Ref 10.151I13v03

21 July 2016

Re: Amended Access Arrangement and Internal Road relating to 110-114 Herring Road, Macquarie Park – Design Review Statement

Design Review - 12.5m HRV circulating internal road (eastern half)

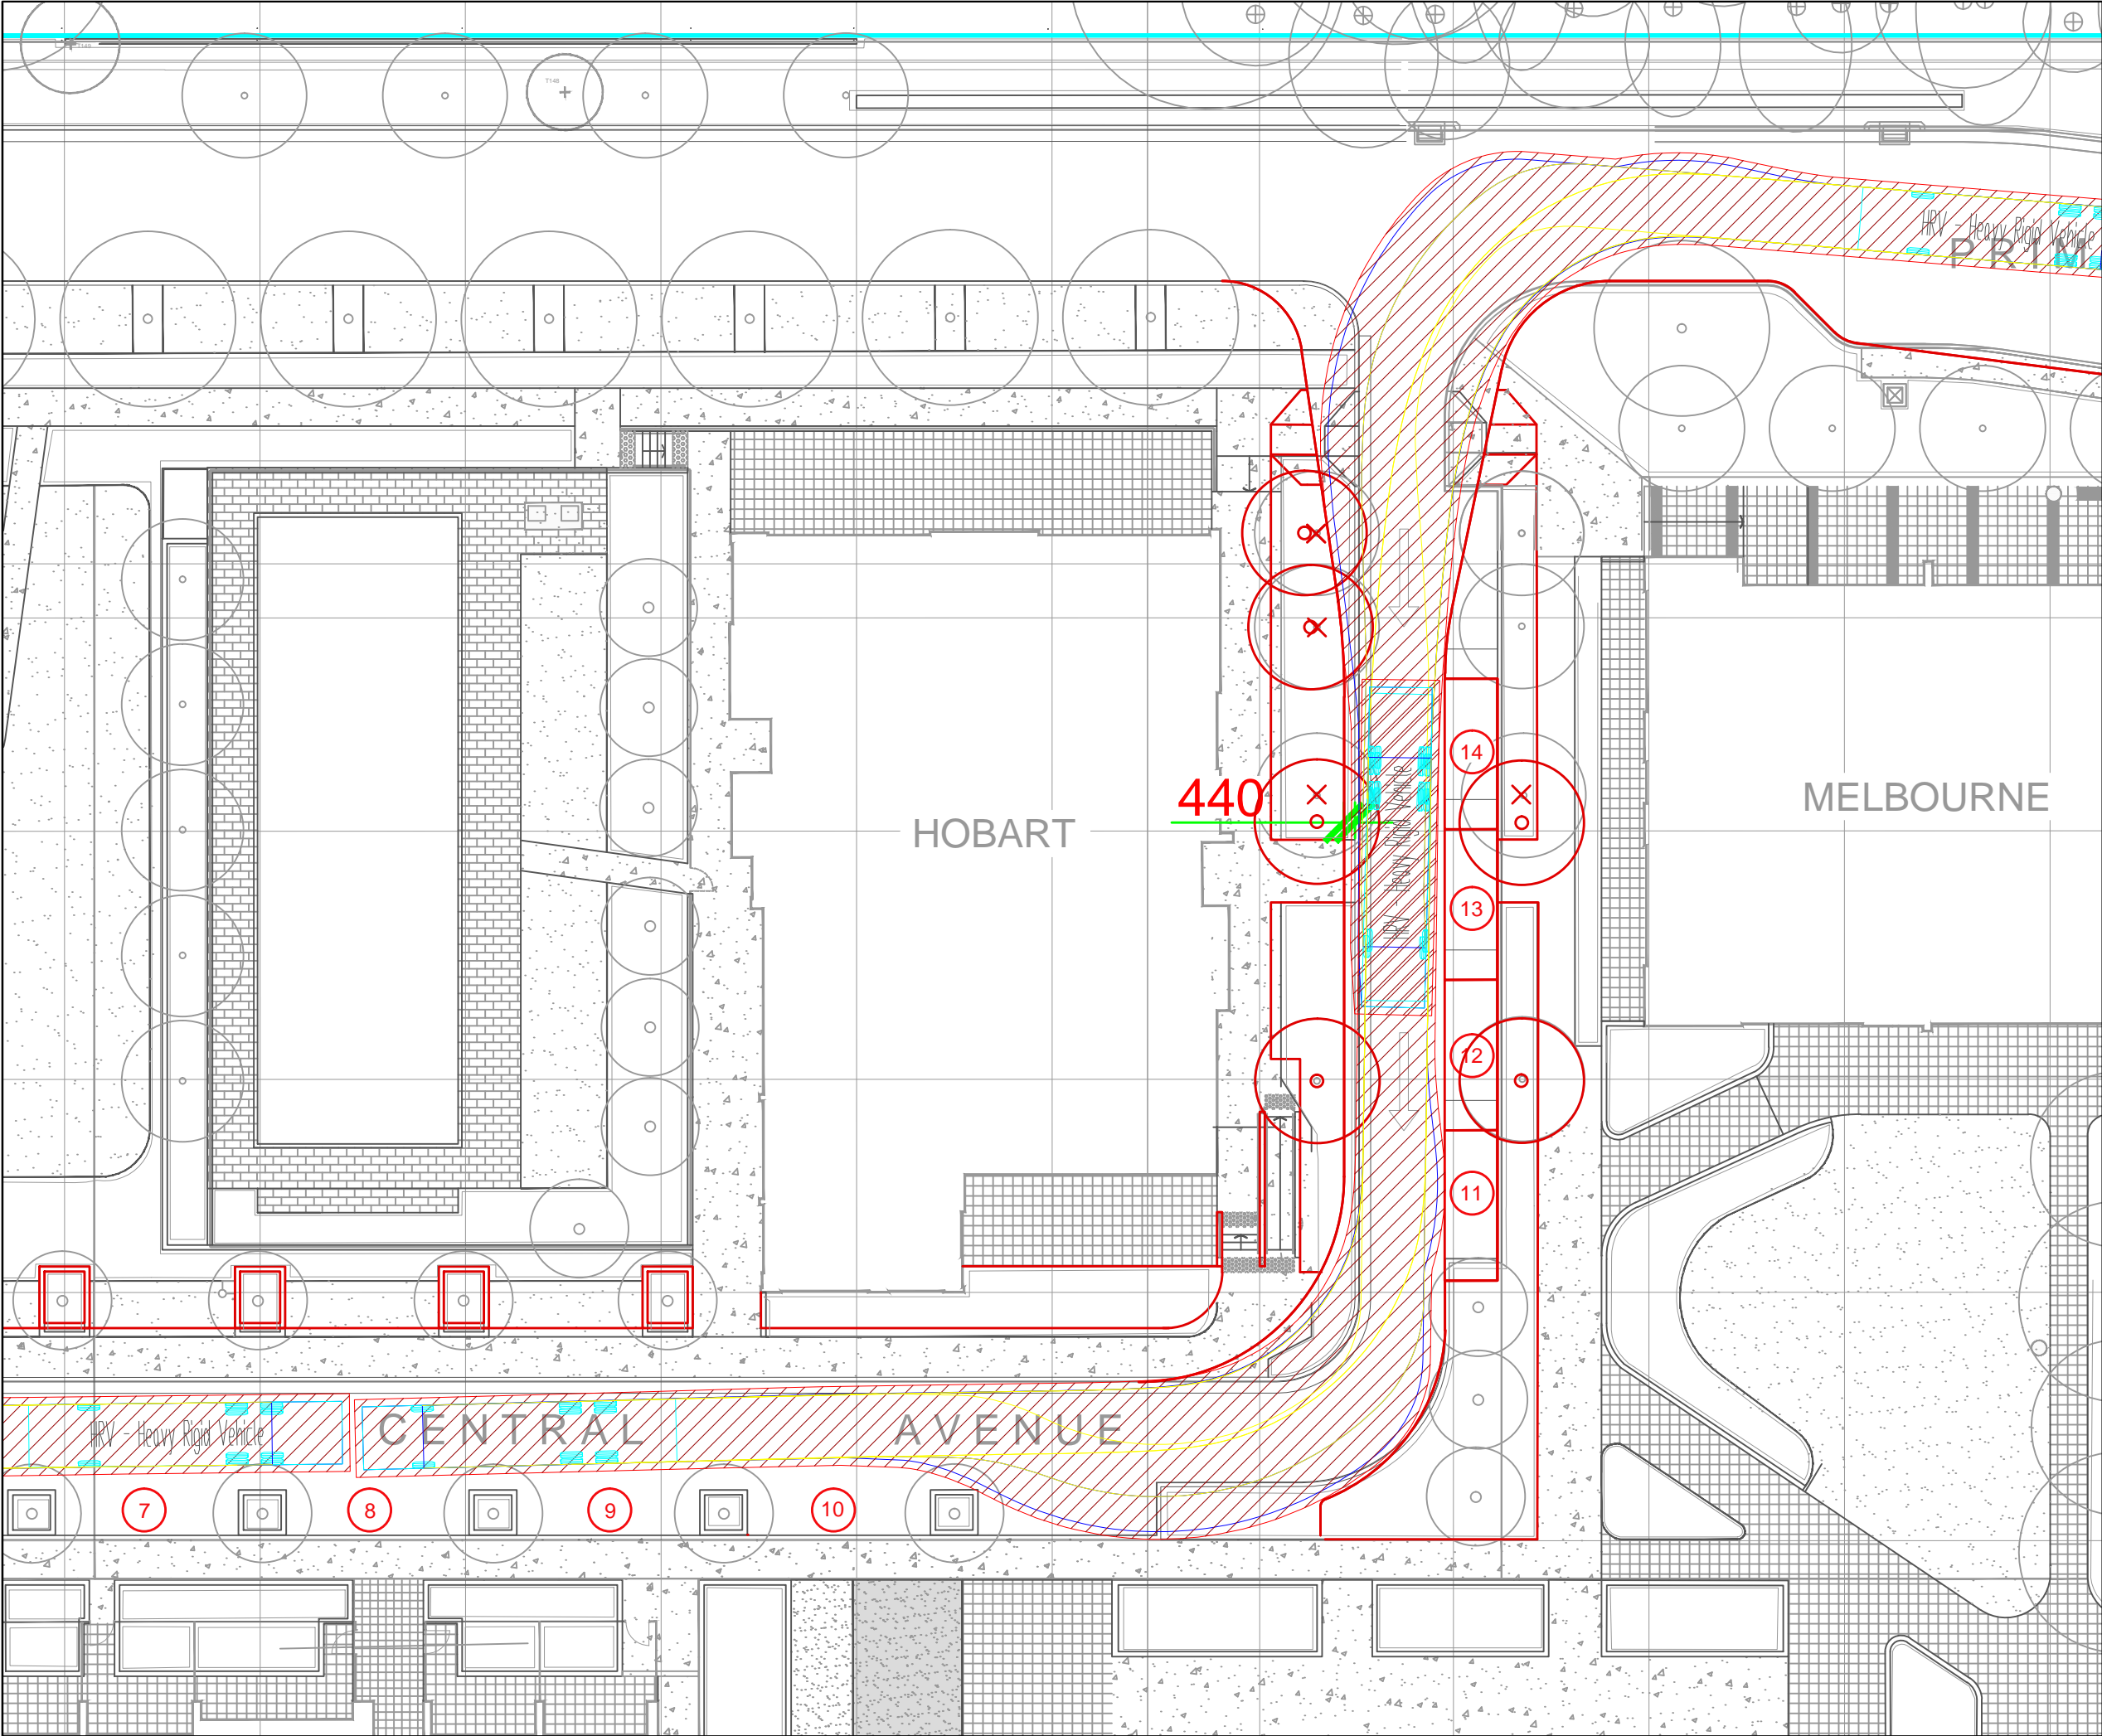
A Swept Path Analysis undertaken using a 12.5m HRV demonstrates the provision for the emergency vehicle to now access all areas of the site as required. This swept path analysis can be viewed in **Attachment C**.
